# PARTS & SERVICE NEWS

REF NO.	AT00115
DATE	Jul. 10, 2000

**SUBJECT:** INTRODUCTION OF SMALL-DIA. FAN FOR SA6D140E ON GD825A-2  
(FOR USE ON ALREADY SHIPPED MACHINES ONLY)

**APPLICATION:** GD825A-2 Motor Graders, Serial Nos. 12051 thru 12098  
(Engine Nos. 23227 thru 28115)

3. Contents of the modification

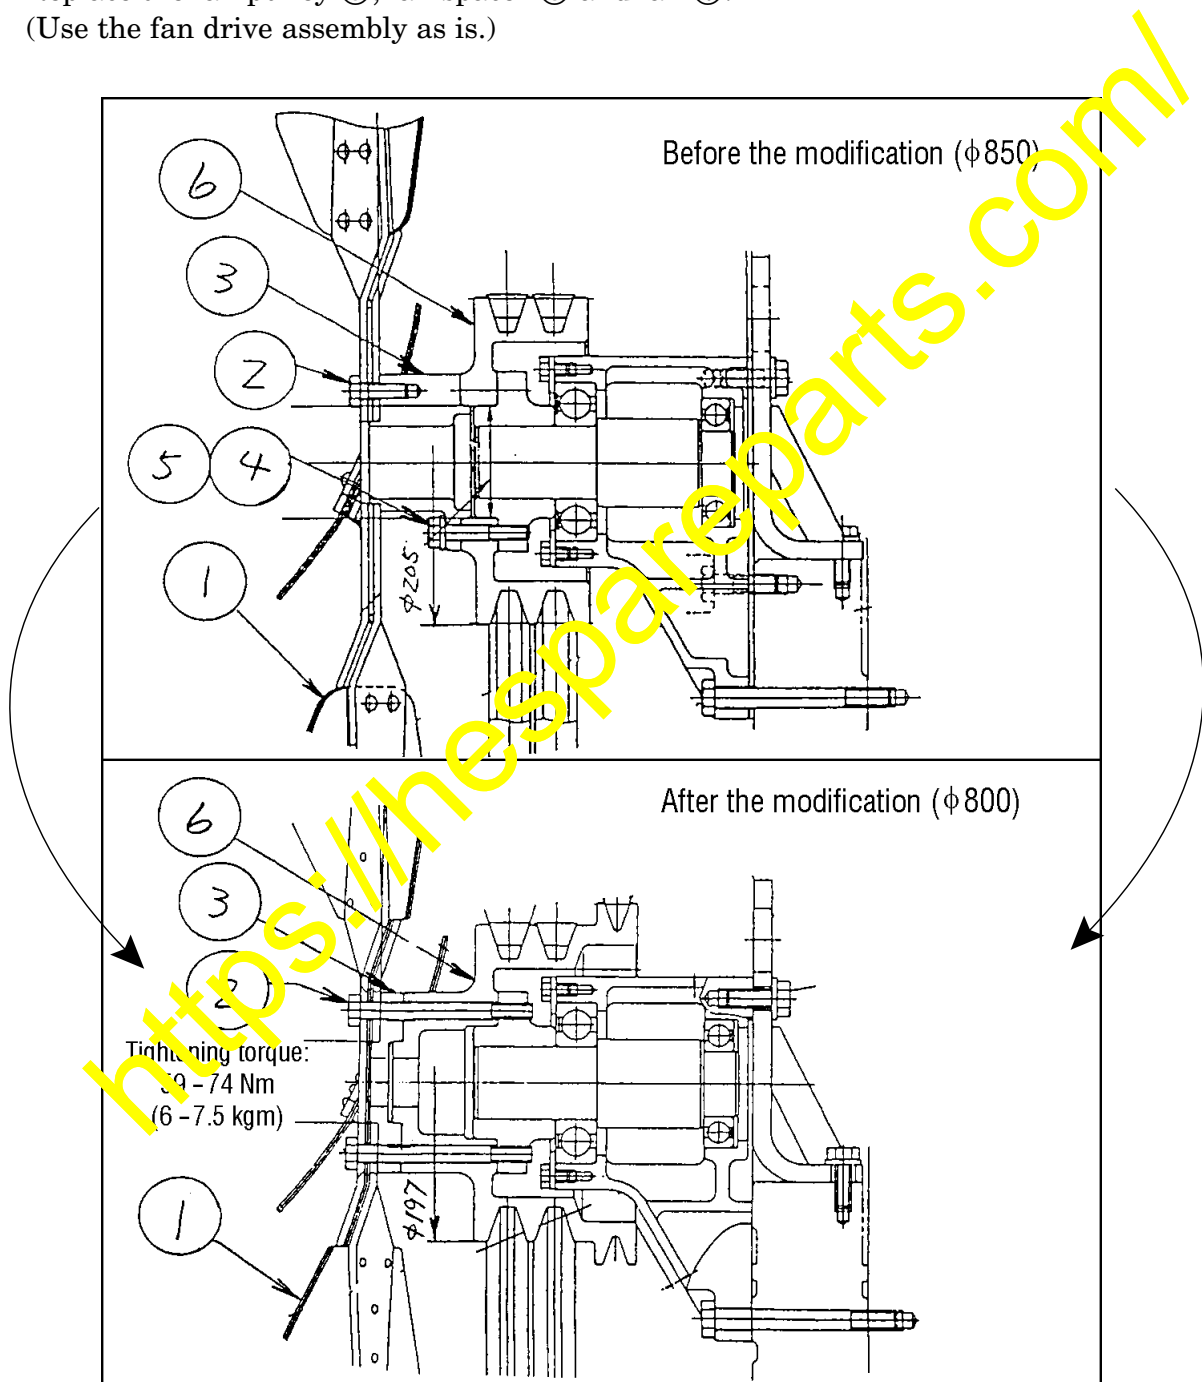
The diameter of the fan has been reduced ( $\phi 850 \rightarrow \phi 800$ ) to raise the resonant revolution rate of the fan.

Replace the fan pulley ⑥, fan spacer ③ and fan ①.

(Use the fan drive assembly as is.)

When adjusting the V-belt after finishing replacement of the fan and the relevant parts, adjust the tension pulley so that the flexure occurring when depressing the center point between the fan pulley and the crank pulley on the V-belt at a force of about 58.8 N (about 6 kg) may become 8 to 12 mm.

## 5. Modification procedures on the chassis side

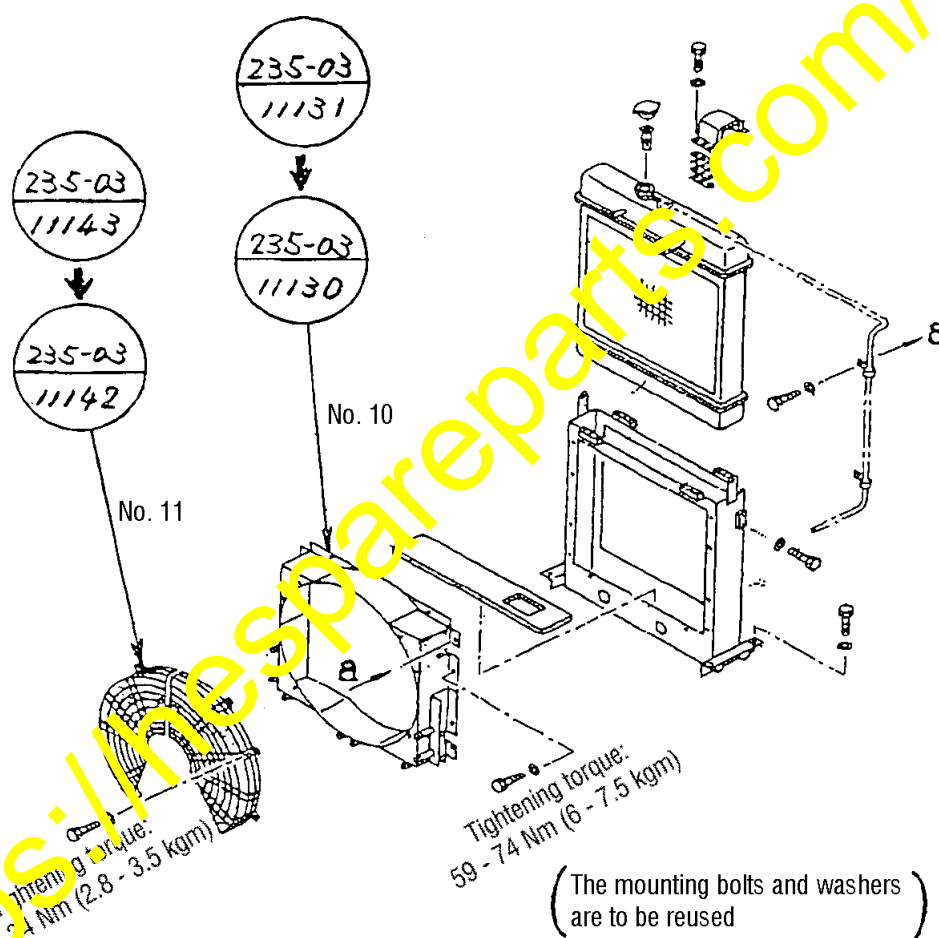
Necessary modification on the chassis side to modify the engine fan diameter ( $\phi 850 \rightarrow \phi 800$ ) is to change the radiator shroud and the wire net.

## (2) Replace the shroud and wire net.
